**Albany Beach Restoration and Public Access Project at McLaughlin
Eastshore State Park – Phases 2 and 3**

BCDC Permit Number 2014.005.01

**BAY CONSERVATION AND DEVELOPMENT COMMISSION
DESIGN REVIEW BOARD AND STAFF COMMENTS, APRIL 17, 2017**

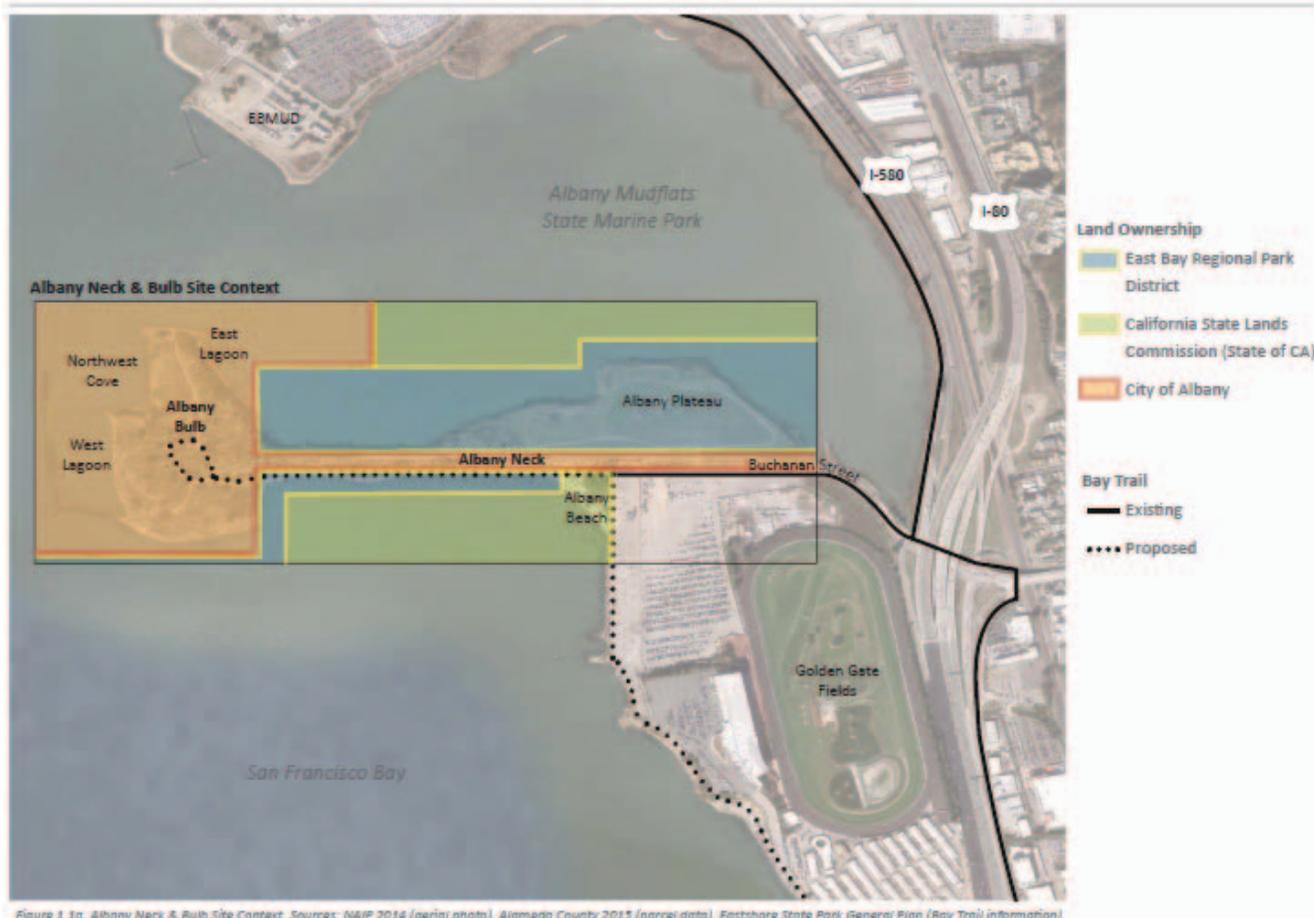
Comment: Create a sense of arrival at the northern end of the project site by clustering amenities and activities. (we recognize the limitations of the project scope).

Comment: The Board recommended that the applicants consider the sequence of the experience of the place – visitors enjoying the views from the Bay Trail or driving to the location to drop off watercraft.

It is agreed that the entry point to McLaughlin Eastshore State Park at Albany Beach, indeed the entrance to the entire Albany Plateau, Neck and Bulb lacks a "sense of arrival and place and that these elements all come together at the existing Buchanan Street turnaround.

The existing entry experience of the State Park starts at the I-880 / Buchanan Street interchange and ends at a sub-standard vehicular turnaround. Approaching the turnaround, there are a total of 75 existing 2-hour parking spaces operated by the City of Albany (City) along the Buchanan Street corridor that are used for accessing the Albany Beach, Plateau, and Neck / Bulb combined. There are 32 parallel parking spaces along the north side of Buchanan Street. There are 43 perpendicular parking spaces located on the south side near the end of Buchanan Street. These 43 spaces are located on Golden Gate Fields (GGF) property and have been made available for public use by an informal agreement between GGF and the City. They are also sub-standard, as they are only 14 feet long, and are actually located on GGF property. Buchanan Street itself is 20 feet wide. The paved Bay Trail on the north side of Buchanan is only 8 feet wide, with no shoulder, and at the end of the street there is no well-marked compliant accessible pathway to get to the Beach from the parking area or Bay Trail. The existing vehicular turn around at the end of Buchanan Street has in its center a pedestrian scaled sculpture. A failing port-o-let at the west side of the turnaround visually competes with the sculpture upon arrival. There is no clearly visible Park entry sign or other landscape features that provide a visual clue announcing entry and arrival to the Park, and the current facility lacks adequate way-finding indicating direction to the area's differing geographic destination and use areas, such as the Bulb, Neck, Plateau trail, or the beach and dune areas. No temporary parking or drop-off is currently provided. The designate ADA parking spaces at the end of Buchanan Street are not compliant and force users into the street, without markings or curb ramps. Emergency vehicle access and turn around is also very difficult.

The existing sequence and experience of place for most visitors accessing the Beach involves navigating at times through a very congested area, with abundant conflicts between people unloading and loading and leashing/unleashing multiple dogs in the vehicular travel-way, or getting gear out of their cars to take to the Beach or Bulb. Parking is inadequate on most sunny warm weather days and the parking problem and user conflicts among arriving and departing vehicles, bicyclists, dog walkers, and trail and beach users appears to have been exacerbated as more people visit this area. Increased visitation is principally accounted for because of the City's removal of homeless encampments at the Bulb in 2015. Park visitor use may increase with construction of the East Bay Regional Park District's (District) programmed Phase 2 and 3 improvements. This includes more people arriving by automobiles with bicycles or water sports gear, as well as families who want to enjoy the improved facilities that are provided, including the new restroom and picnic areas.

Some of these existing features and limitations were acknowledged in the District's Albany Beach Restoration & Public Access Plan EIR (2012), and in the City's Albany Neck and Bulb Transition Study, accepted by the City Council in June 2016, and in the City General Plan. The District's Plan addresses some of the accessibility and parking issues (on District and State owned property), emergency vehicle access, and will also provide entry signage and way-finding signage within its operational boundary. Conflicts between visitors crossing the new segments of the Bay Trail from the parking area or at the north end of the Park are managed by controlling access, and by providing visual cues and guiding access to areas with direct access to the beach, at the north and south ends of the dune enhancement area.

In order to adequately respond to the Design Review Board's broad goal of enhancing a sense of entry, additional improvements related to parking, entry signage, and user conflict reduction in the Buchanan Street corridor would need to be made. Such improvements would be on City of Albany / GGF property. They were not reviewed and evaluated in the Albany Beach Restoration & Public Access Plan EIR and therefore cannot be made at this time.
